Portland, Maine, May 17, 1957 Location 42 Alder Street Within Fire Limits? Dist. No. Owner's name and address ..... Errolld. W. Mattatell, 296 Stevens Ave. ..... Telephone ...... Architect Specifications Plans No. of sheets No. Last use \_\_\_\_\_\_\_No. families \_\_\_\_\_\_ Other building on same lot ..... Estimated cost \$..... General Description of New Work To demolish existing 1-story frame warehouse 60' x 30' Lot to be used for parking in connection with apt. house at 40 Alder St. De you agree to tightly and permanently close all sewers or drains connecting with public or private sewers from this building or structure to be demolished under the supervision and to the approval of the Dept. of Public Works of the City Of Portland? It is understood that this permit does not include installation of heating apparatus which is to be taken out separately by and in the name of the heating contractor. PERMIT TO BE ISSUED TO owner Details of New Work Is any plumbing involved in this work? ...... Is any electrical work involved in this work? Is connection to be made to public sewer? ...... If not, what is proposed for sewage? ..... Material of underpinning ....... Height ...... Thickne

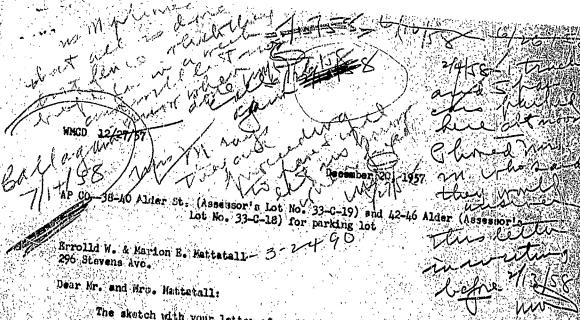
-the lot at 38-40 Alder St. is perhaps four feet higher in the rear than the lot at 42-46 Alder St., and we shall have to know how you intend to care for their difference in elavation (what the grades on the final lot would be), especially wmether or not any retaining walls

of any kind were to be used. -in your letter you have said that all surface water will be drained into a matural drainage way. We shall have to know just what you menn by a natural drainage way, and, of course, the public street cannot be considered as a natural drainage way. Upon inspection of the situation, it appears that there is no curb along Alder St. at this point, just a dirt sidewalk, and the sidewalk is rutted as though water had run down across it in considerable quantity. It will be necessary for you to show on your site plan just how you intend to take care of this drainage situation. If there is any question of drainage upon the public street, we will ask the opinion of the Department of Public Works about the proposition.

on the sketch which Traific Engineer Connor has approved you show a 12 foot wide approach to the lot from Alder Street over the public sidewalk, but there is nothing to indicate how you intend to set this approach out. Did you propose curb cornets at this driveway or how did you intend to set it out so that persons cannot drive over the sidewalk anywhere?

In regard to the difference in elevation between the two lots, 38-40 and 42-46 we expect to have a bulldozer to cut the lot down, in back of the house, about 18 ins. to 2 ft. and slope gradually to the next lot, having it black topped.

After talking with you again we shall decide whether to have a catch basin or natual drainage.

We plan to have afence as our other letter stated and a 12 foot opening for entrance, also, macadamized over sidewalk into street if this is satisfactory.
